Bethesda Downtown Design Advisory Panel (DAP)

Project Name	7340 Wisconsin Avenue				
File Number(s)					
Project Address	7340 Wisconsin Avenue				
Plan Type Concept Plan Sketch Plan Site Plan Consultation w/o Plan APPLICANT TEAM					
	Name	Phone	Email		
Primary Contact	Patricia A. Harris 301-841-3832		paharris@lerchearly.com		
Architect	Andy Czajkowski, SK+I; 240-479-7488; aczajkowski@skiarch.com				
Landscape Architect	TBD

Memorandum

Re: 7340 Wisconsin Avenue – Supplemental DAP Submission

7340 wisconsin ave	bethesda md			july 12, 2022		A.11
SK+I Greystar LandDesign	building sections	0	25'	50'	100'

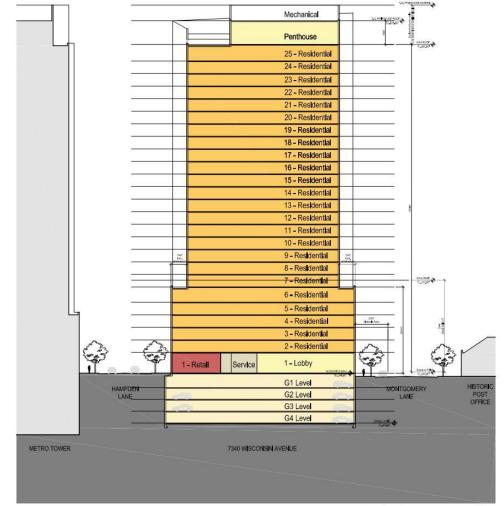
1. Relationship of building to the proposed building to the west.

2. Reevaluation of the curtain wall.

The Project's first floor will be located essentially on the western Property line. Portions of floors two through six will be located on the western Property line, except that there is a courtyard "cut out" in the center with a depth of 22.5 feet with a bio planter at the second floor level. The remaining western façade of the building above the sixth floor will be setback 22.5 feet from the western Property line.

One member of the DAP Committee commented that the curtain wall at the top of the building may be awkward and that the Applicant should reevaluate this. This was reevaluated and the architects decided to maintain the same design concept given that it worked well with the

overall design. However, the top portion of the building will be built slightly differently from the window wall system below, but the vertical framing detailing will extend beyond the occupied floors to continue the building's verticality. These extensions will create the screening needed at the amenity roof and penthouse roof levels. There will be infill panels between the frames that will be either glass or louvers, depending on the function of the space behind it.
